JOCPROJ- EDINBURG CONCESSION 2025 Addendum #1

South Texas ISD Concession Storage Building – Edinburg Texas

ADDENDUM NO. 1

01 WALL SECTION
 SCALE: 3/4" = 1'-0"

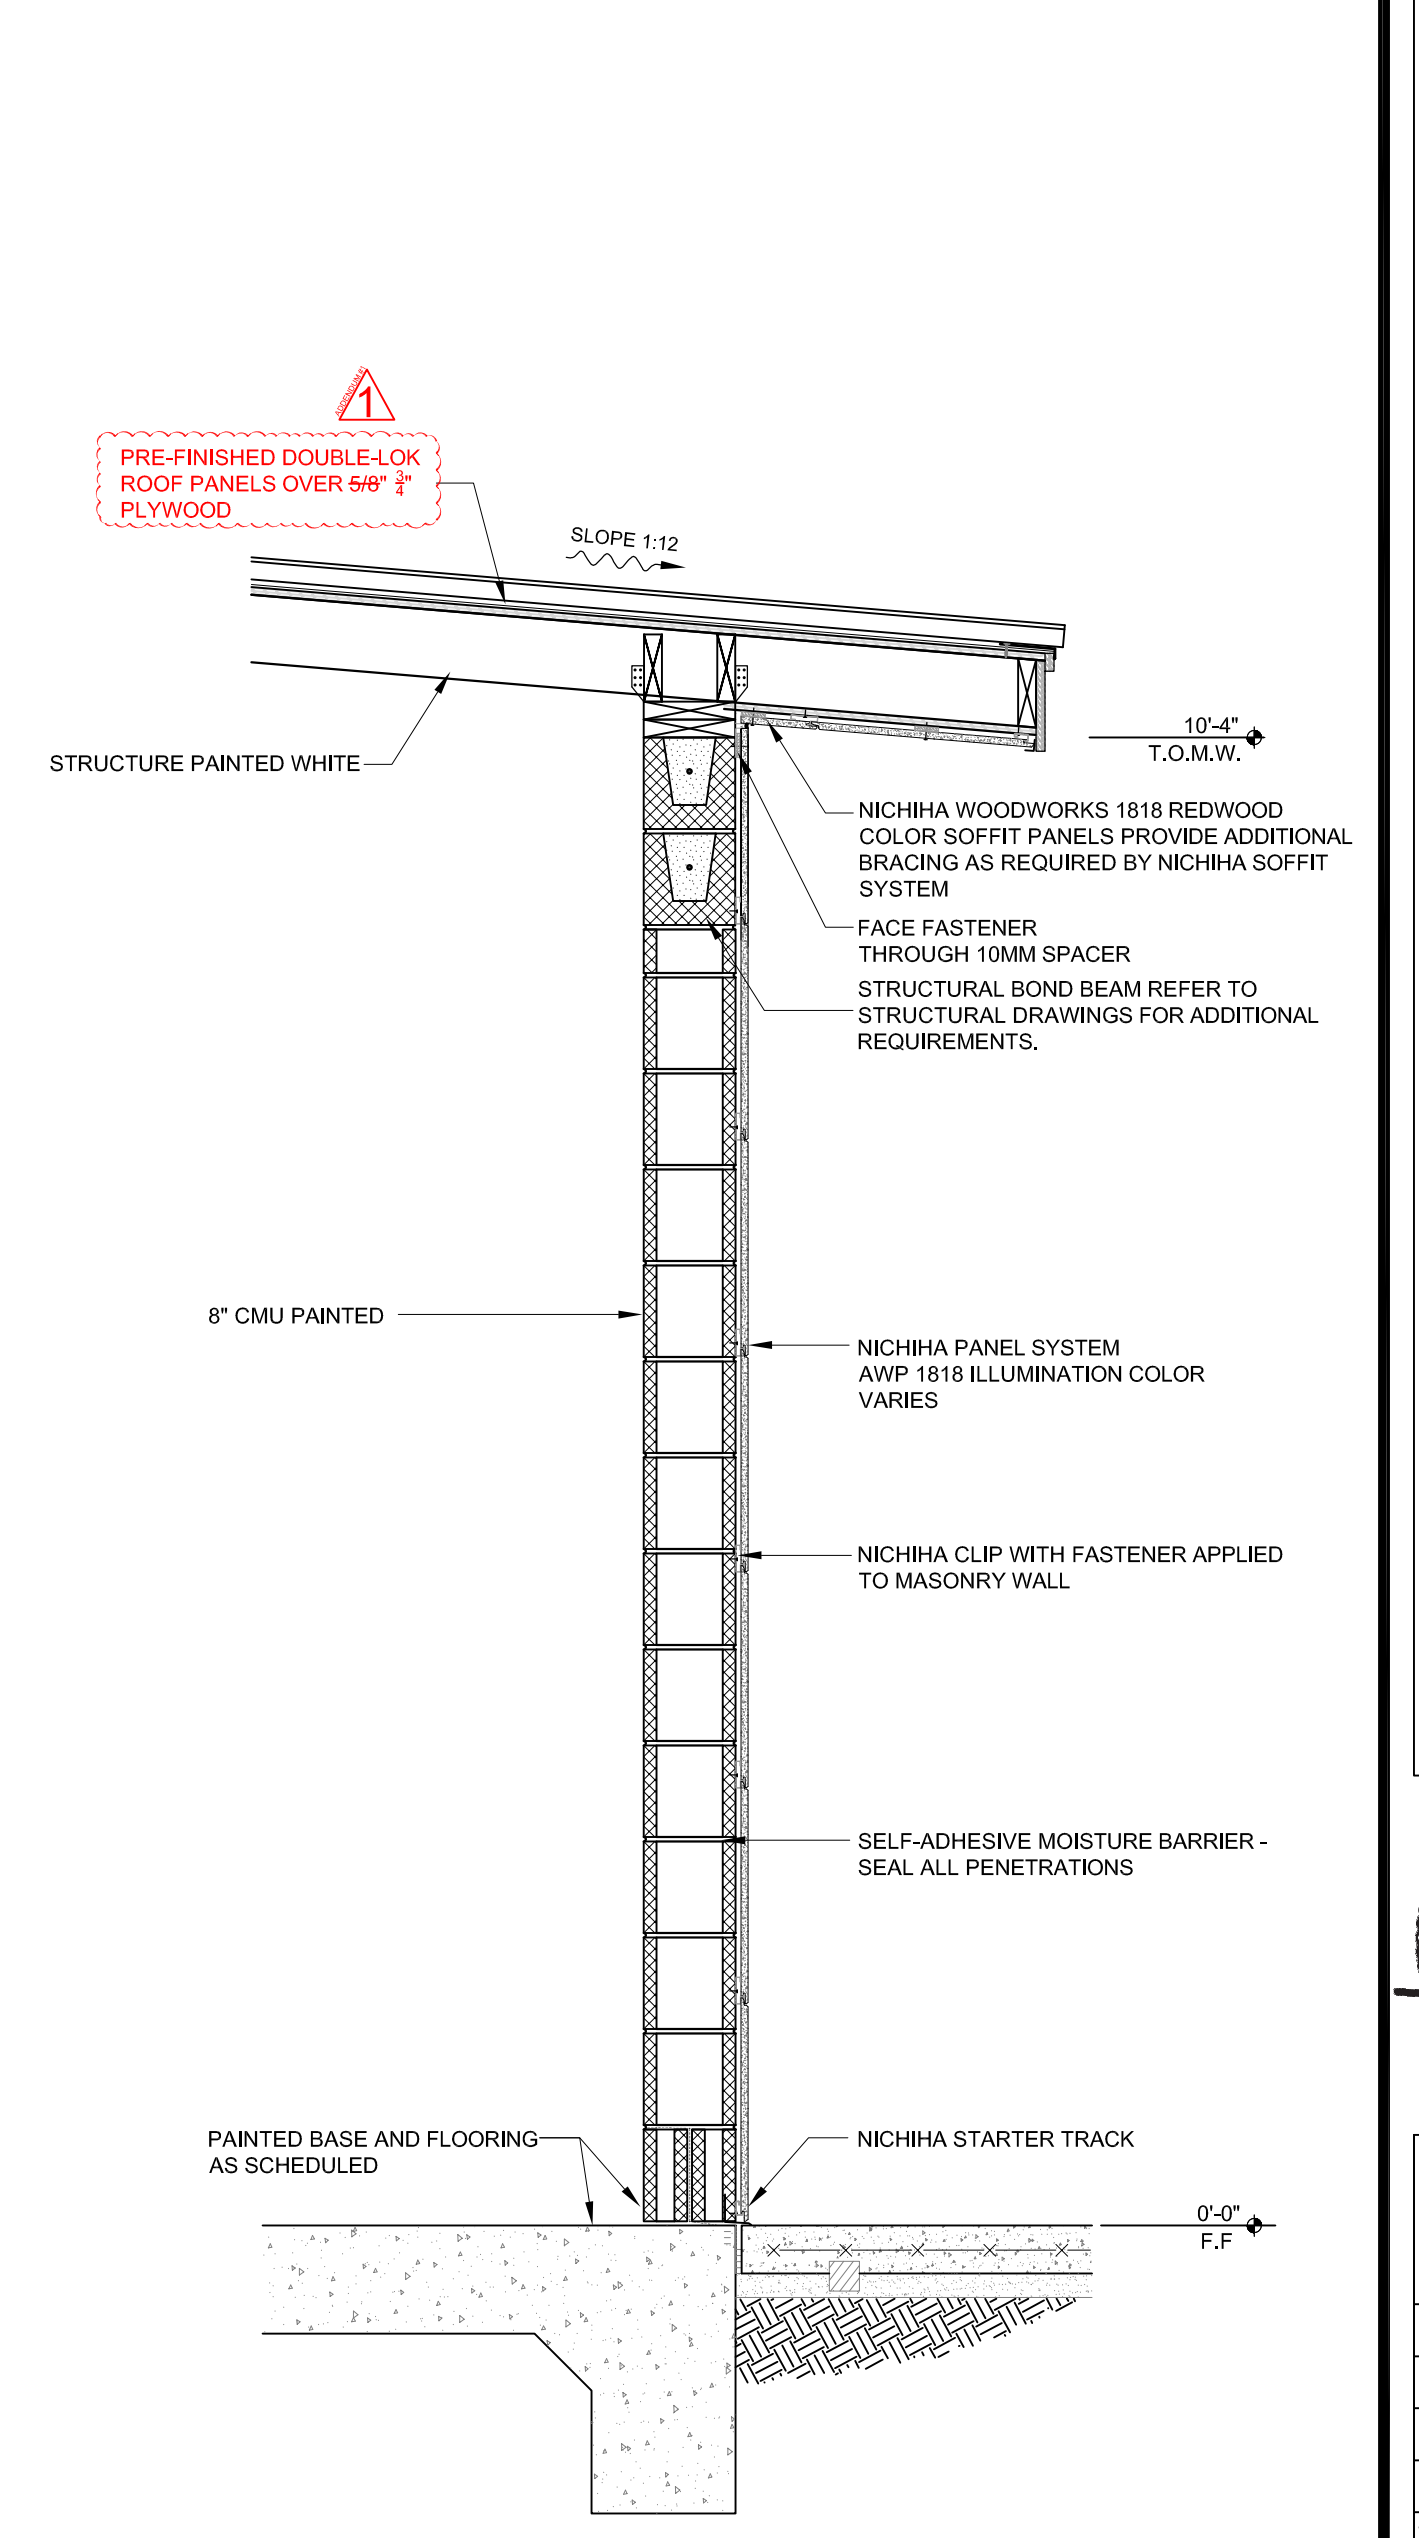
1. A4.01
 - a. Wood sheathing shall be ¾" thick in lieu of 5/8" to match Sheet S1.0
2. Sheet S1.2
 - a. Minimum Depth of excavation shall be 3'-0" in lieu of 4'-0" previously shown
3. P2.01 General Notes
 - a. Delete general note 5

REVISION NOTE TO READ SHEATHING IN LIEU OF 8" SHEATHING

P2.01

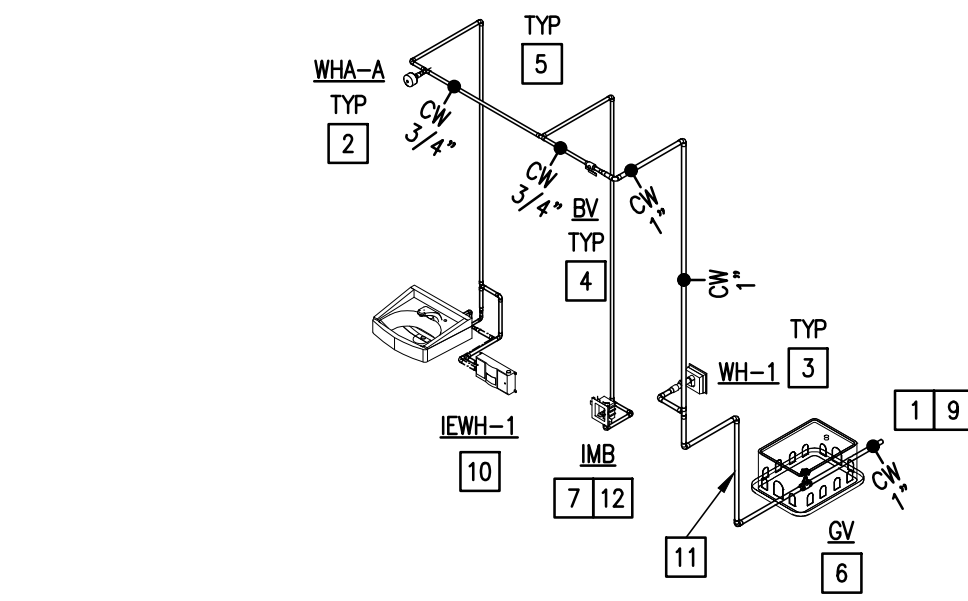
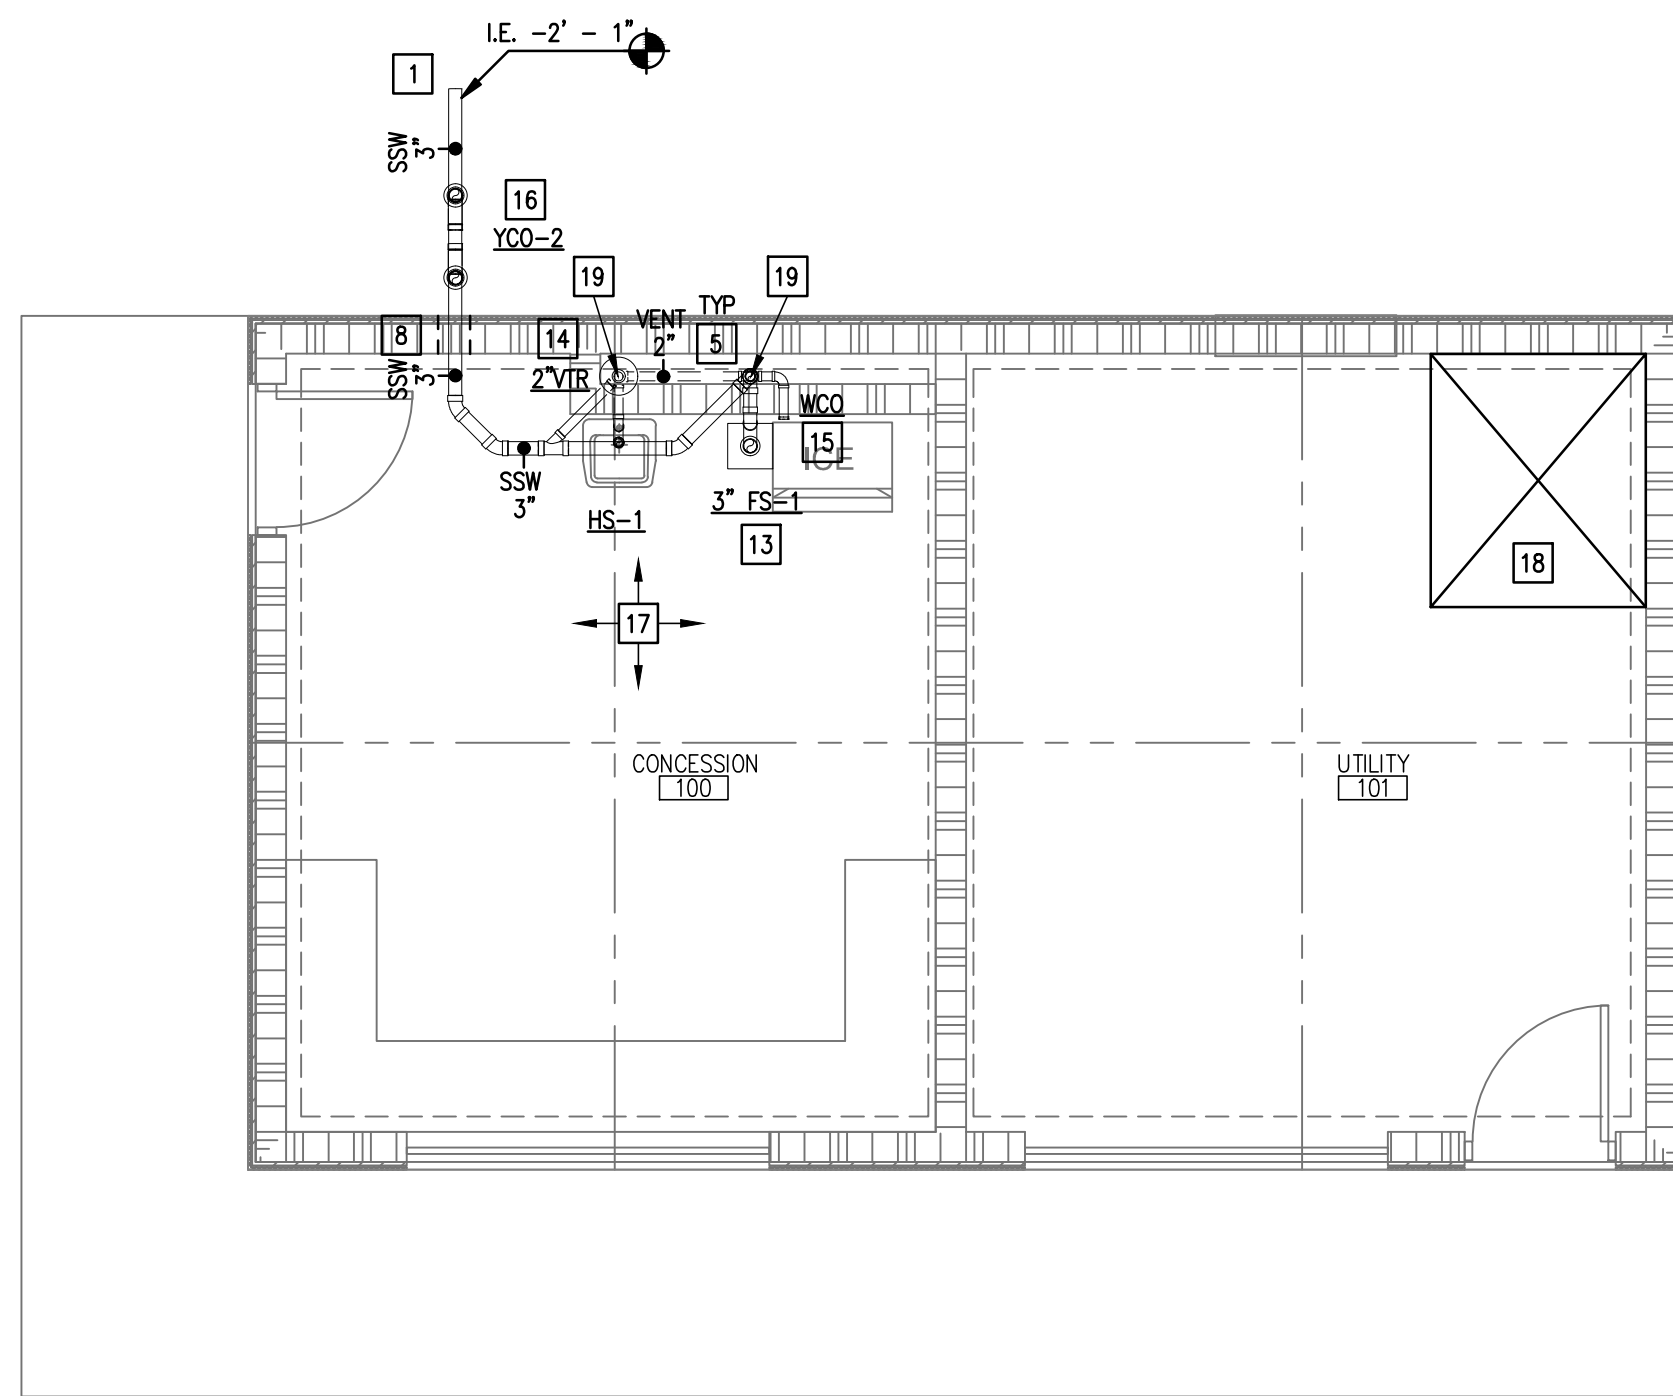
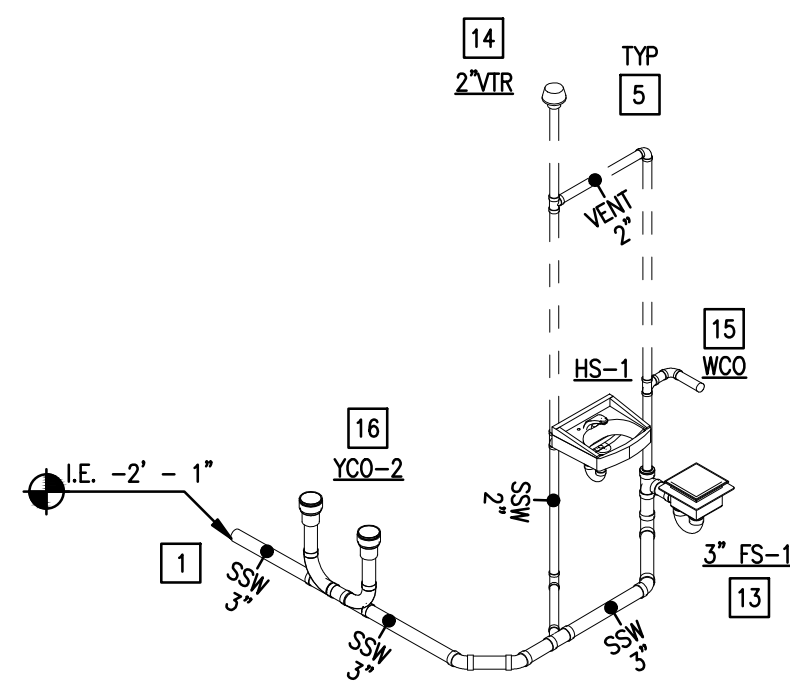
1. Sheet P2.01:
 - a) Revised General notes.

1. NOT ALL ACCESSORIES REQUIRED FOR INSTALLATION ARE SHOWN ON DRAWINGS FOR CLARITY. SEE ASSOCIATED DETAILS ON THE DETAILS SHEET FOR INSTALLATION AND SPECIFICATIONS.
2. ALL POINTS OF CONNECTION OF EQUIPMENT SHOWN ON PLANS (WATER HEATERS, ETC.) ARE SCHEMATIC IN NATURE. ISOMETRIC VIEWS PROVIDE A GENERAL IDEA OF WHERE THESE POINTS OF CONNECTION COULD BE. CONTRACTOR SHALL VERIFY EXACT LOCATION OF POINTS OF CONNECTION WITH EQUIPMENT CUTSHEETS DURING SUBMITTAL PROCESS AND INSTALLATION ACTIVITIES.
3. INVERTED ELEVATIONS SHOWN IN PLUMBING PLANS ARE BEST APPROXIMATIONS AND CAN BE IMPROVED DURING CONSTRUCTION.
4. ALL NEW SANITARY SEWER SYSTEM IS REQUIRED TO HAVE A MINIMUM OF 1/8" FT SLOPE (1%)
5. NOT USED.
